Access Compliance Report

Public Rights-of-Way

(Curb Ramps)

Intersection ID: 53019	Main Street: BILLET_LN	Cross Street: CHARTRES_LN	Location: SE
ADA ID: 48829DE0B553	Ramp Type: BlendTrans2	Initial Pass/Fail: Fail	Overall Compliance: No
Severity Score: 1.25			
Codes/Mitigation Info/Possible Solution		Field Measurements/Component Compliance

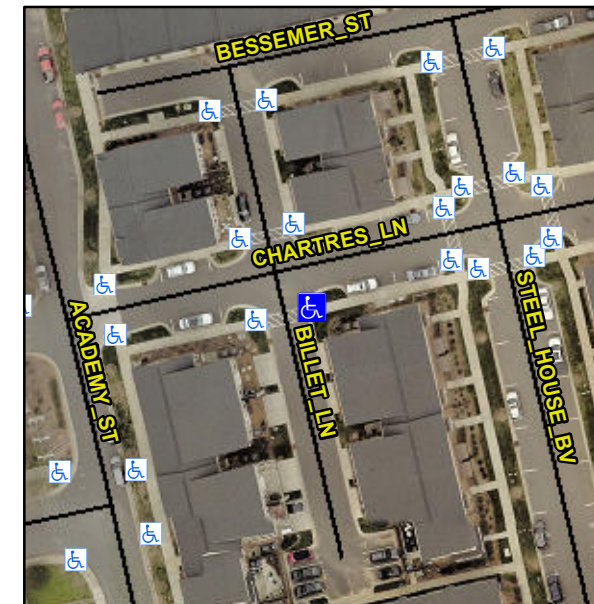
Not Found, R304.5.3

Compliance	Description	Data	Compliance	Description	Data
N/A	Ramp Length (in)	24.0	Yes	BlendTrans Slope (%)	3.4
Yes	Ramp Width (in)	67.0	No	BlendTrans XSlope (%)	2.1
N/A	Flare Type LT	None	N/A	Flare Type RT	None
N/A	Flare Slope LT (%)	N/A	N/A	Flare Slope RT (%)	N/A
N/A	Flare Traversable LT?	N/A	N/A	Flare Traversable RT?	N/A
N/A	Landing Length (in)	N/A	N/A	DWS Provided?	Yes
N/A	Landing Width (in)	N/A	N/A	DWS Contrast?	Yes
N/A	Landing Slope (%)	N/A	N/A	DWS Length (in)	24.0
N/A	Landing X Slope (%)	N/A	N/A	DWS Full Width?	No
N/A	Landing Curb? (Y/N)	No	N/A	DWS Offset (in)	6.5
N/A	Shared Landing?	No			
N/A	Gutter Ponding?	No	N/A	Gutter Slope (%)	8.6
N/A	Gutter Lip Ht (in)	0.3	N/A	Gutter X Slope (%)	1.9
N/A	Painted X Walk1?	Yes	N/A	Painted X Walk2?	N/A
	X Walk 1 Direction	To W		X Walk 2 Direction	N/A
	X Walk 1 Width (in)	67.0		X Walk 2 Width (in)	N/A
	X Walk 1 Slope (%)	1.4		X Walk 2 Slope (%)	N/A
	X Walk 1 X Slope (%)	2.6		X Walk 2 X Slope (%)	N/A

N/A	Ramp inside XWalk1?	Yes	N/A	Ramp inside XWalk2?	N/A
	Road Slope (%)	2.6		Clear Space?	Yes
	Road X Slope (%)	1.4	N/A	Clear Space to XWalk (in)	N/A
N/A	Any Obstructions?	No	N/A	Storm Grate/Utility Hazard?	No
	Obstruction Type			Storm Grate/Utility Type	
		N/A			N/A
		Yes		Surface Condition? (G/P)	Good
		No		Curb Slope (%)	9.8

Remove & Replace Curb Ramp With Two New Directional Ramps or Equivalent.
